**15-DAY EXPRESS TERMS  
FOR  
PROPOSED BUILDING STANDARDS  
OF THE  
CALIFORNIA STATE LANDS COMMISSION**

**REGARDING PROPOSED CHANGES TO  
THE CALIFORNIA BUILDING CODE  
CALIFORNIA CODE OF REGULATIONS, TITLE 24, PART 2,  
CHAPTER 31F – MARINE OIL TERMINALS**

**2016 CALIFORNIA BUILDING CODE  
TRIENNIAL CODE CYCLE**

**15-DAY EXPRESS TERMS**

**FIGURE 31F-4-7**  
**EFFECTIVE LATERAL STIFFNESS (ADAPTED FROM [4.4])**

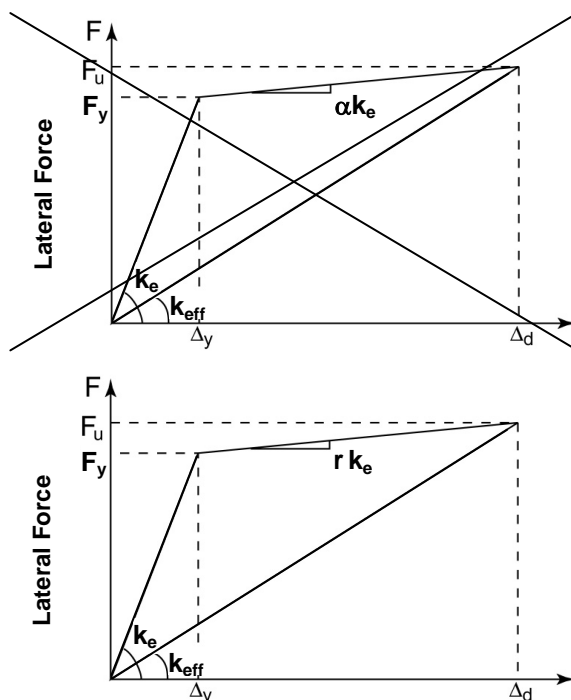
**4.27.** Add new Figure 31F-4-7:

**Rationale:** Based on public comment, “ $\alpha$ ” is corrected to “ $r$ ” for consistency with the symbolism utilized in Section 3104F.2.3.2.2 (i.e. Express Term #4.23) and Figure 31F-4-5 (i.e. Express Term #4.24).

Furthermore, based on public comment, the term “*EFFECTIVE*” has been added to the figure title for consistency with the effective elastic lateral stiffness (“ $k_e$ ”) and effective secant lateral stiffness (“ $k_{eff}$ ”) terminology in Section 3104F.2.3.2.2 *Substitute Structure Method* (i.e. Express Term #4.23).
